Access Compliance Report

Public Rights-of-Way (Curb Ramps)

Intersection ID: 2501	Main Street: BENTGRASS_RUN_DR	Cross Street: WHISTLER'S_CHASE_DR	Location: N
ADA ID: BBDA3B570BE6	Ramp Type: PerpDiag	Initial Pass/Fail: Fail	Overall Compliance: No
Severity Score: 37.5			
Codes/Mitigation Info/Possible Solution		Field Measurements/Component Compliance

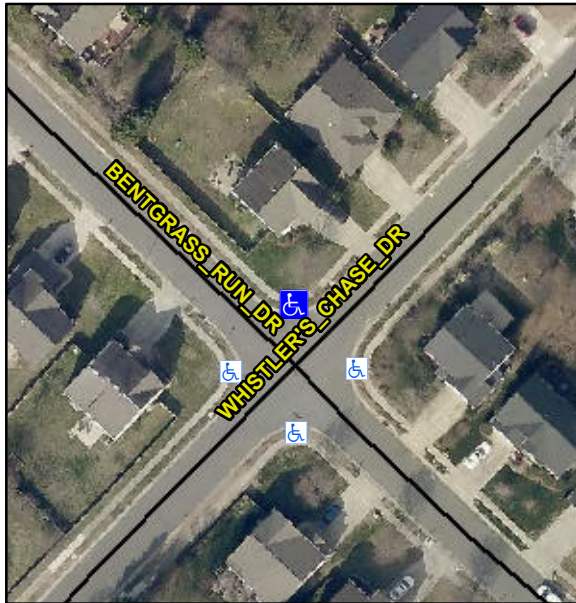
Not Found, R304.2.2, R304.5.3

Compliance	Description	Data	Compliance	Description	Data
N/A	Ramp Length (in)	46.0	No	Ramp Slope (%)	11.2
Yes	Ramp Width (in)	53.5	No	Ramp XSlope (%)	9.8
N/A	Flare Type LT	N/A	N/A	Flare Type RT	N/A
N/A	Flare Slope LT (%)	N/A	N/A	Flare Slope RT (%)	N/A
N/A	Flare Traversable LT?	N/A	N/A	Flare Traversable RT?	N/A
N/A	Landing Length (in)	N/A	N/A	DWS Provided?	N/A
N/A	Landing Width (in)	N/A	N/A	DWS Contrast?	N/A
N/A	Landing Slope (%)	N/A	N/A	DWS Length (in)	N/A
N/A	Landing X Slope (%)	N/A	N/A	DWS Full Width?	N/A
N/A	Landing Curb? (Y/N)	N/A	N/A	DWS Offset (in)	N/A
N/A	Shared Landing?	N/A			
N/A	Gutter Ponding?	N/A	N/A	Gutter Slope (%)	N/A
N/A	Gutter Lip Ht (in)	N/A	N/A	Gutter X Slope (%)	N/A
N/A	Painted X Walk1?	No	N/A	Painted X Walk2?	No
	X Walk 1 Direction	To SW		X Walk 2 Direction	To SE
N/A	X Walk 1 Width (in)	N/A	N/A	X Walk 2 Width (in)	N/A
	X Walk 1 Slope (%)	6.4		X Walk 2 Slope (%)	3.2
	X Walk 1 X Slope (%)	5.4		X Walk 2 X Slope (%)	4.5

N/A	Ramp inside XWalk1?	N/A	N/A	Ramp inside XWalk2?	N/A
	Road Slope (%)	6.9	N/A	Clear Space?	N/A
	Road X Slope (%)	2.9	N/A	Clear Space to XWalk (in)	N/A
N/A	Any Obstructions?	N/A	N/A	Storm Grate/Utility Hazard?	N/A
	Obstruction Type			Storm Grate/Utility Type	
		N/A			N/A
		Yes		Surface Condition? (G/P)	Good

Remove & Replace Curb Ramp With Two New Directional Ramps or Equivalent.
